Proposed changes to planning controls in the Area 20 Precinct

**Blacktown City Submission to
Proposed Changes to Planning Controls in the Area 20 Precinct**

Draft Indicative Layout Plan

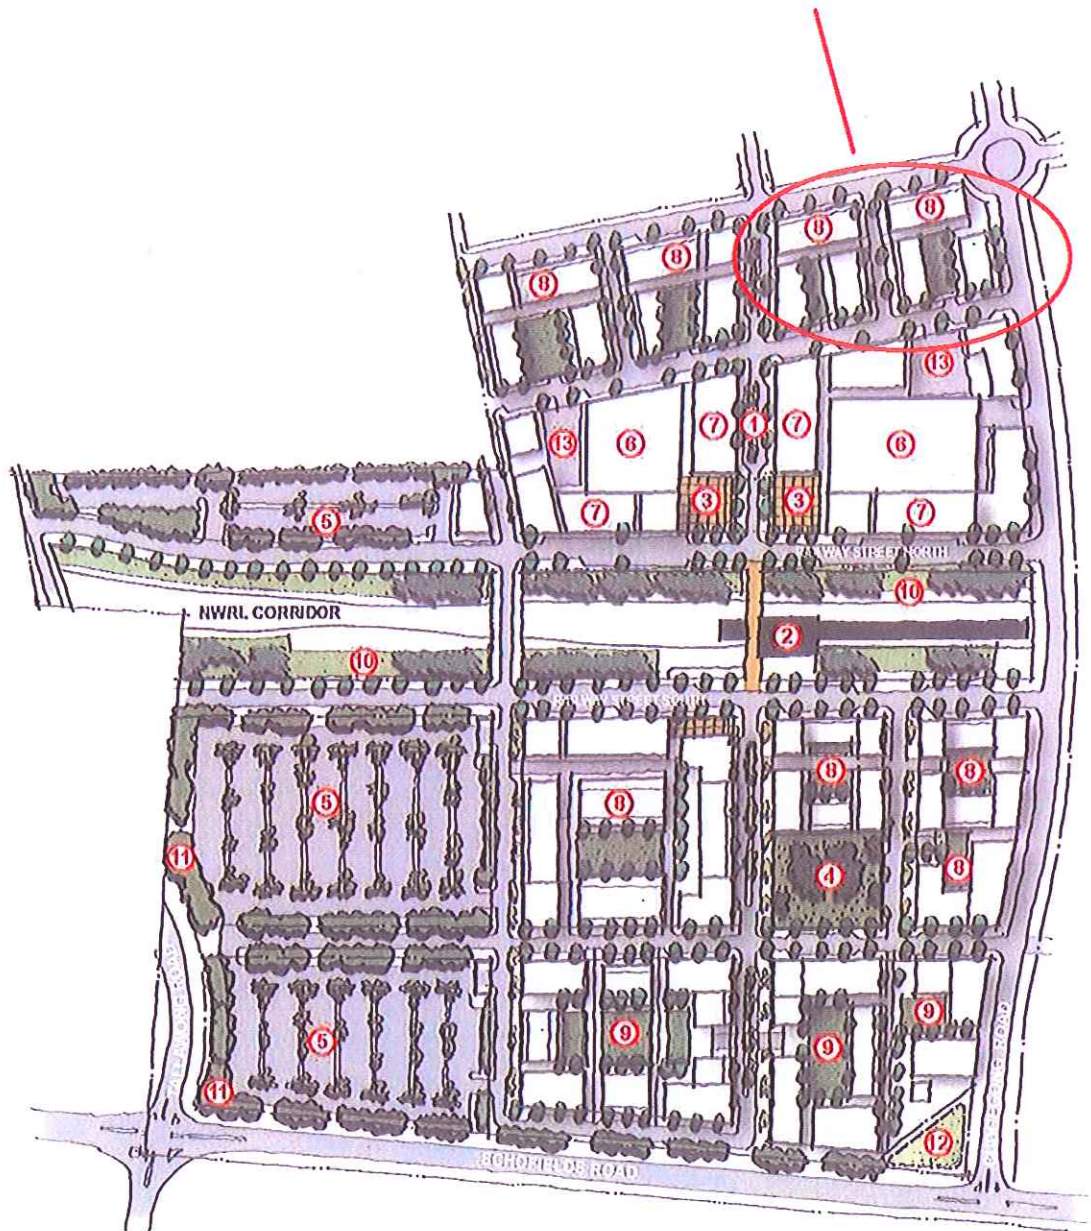
This section of drainage can be deleted

What are level differences and can these road connections to overpass be achieved?

Need details of amended and extra drainage elements

Delete this section of drainage

Extra road crossing over railway will add cost to S94 and hard to justify on demand

Adjust ILP & zoning maps to suit RMS works and boundaries

What is intended use of redundant section of Cudgong Road? Parking, drainage, other?
